MECKLENBURG COUNTY
DEPARTMENT OF ENVIRONMENTAL HEALTH

SITE EVALUATION

OWNER: LYNDA JONES
ADDRESS: R-4 Box 706
Huntersville 28078
LOCATION OF SITE: off Mallard Creek Rd
Lot 3.

RE: Property located at Off Mallard Creek Road, Lot 3

**See Diagram on Back (includes: soil areas, property lines, roads, streams, gullies, wet areas, fill areas, wells, water bodies, slopes)

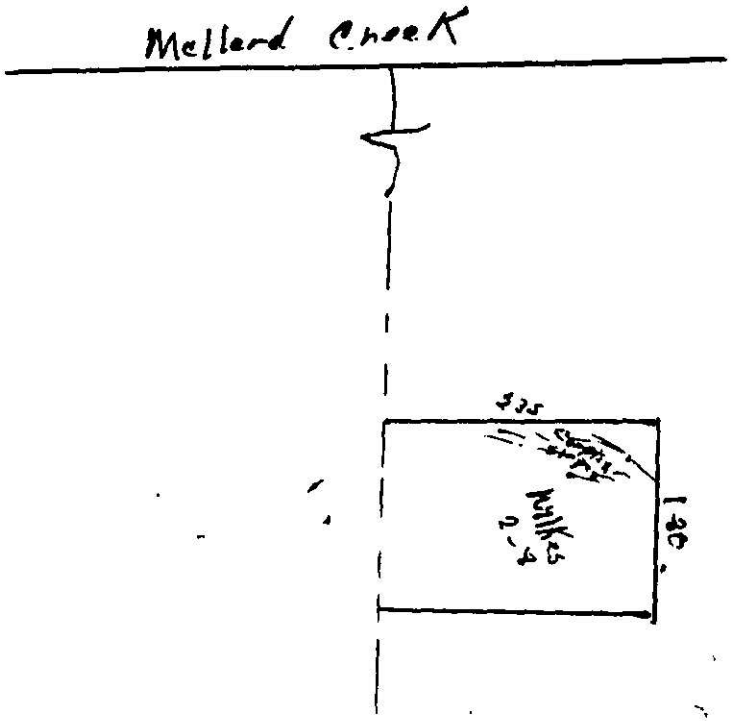
FACTORS	AREA 1	AREA 2	AREA 3	AREA 4
1. SLOPE (%)	S (PS) 2-8 U	S PS Complex Slopes U	S PS U	S PS U
2. SOIL TEXTURE (12-36 inches) Sandy, Loamy, Clayey (Note 2-1 Clay)	S PS Mixed Clay (U)	S PS U	S PS U	S PS U
3. SOIL STRUCTURE (12-36 inches)	S PS Weak Blocky (U)	S PS U	S PS U	S PS U
4. SOIL DEPTH (inches)	S PS 12-15" (U)	S PS U	S PS U	S PS U
5. RESTRICTIVE HORIZONS (Inches) (Impervious strata, Rock)	S PS None (U)	S PS U	S PS U	S PS U
6. SOIL DRAINAGE/GROUNDWATER (external and internal)	S PS Slow (U)	S PS U	S PS U	S PS U
7. OTHER (Specify)	S PS U	S PS U	S PS U	S PS U
8. SOIL GROUP	IVa	IVa		
9. SITE CLASSIFICATION	Unsuitable	Unsuitable		
10. SOIL SERIES	Wilkes	Complex Slope in Wilkes

Mellard Creek
235
180
Wilkes
2-4
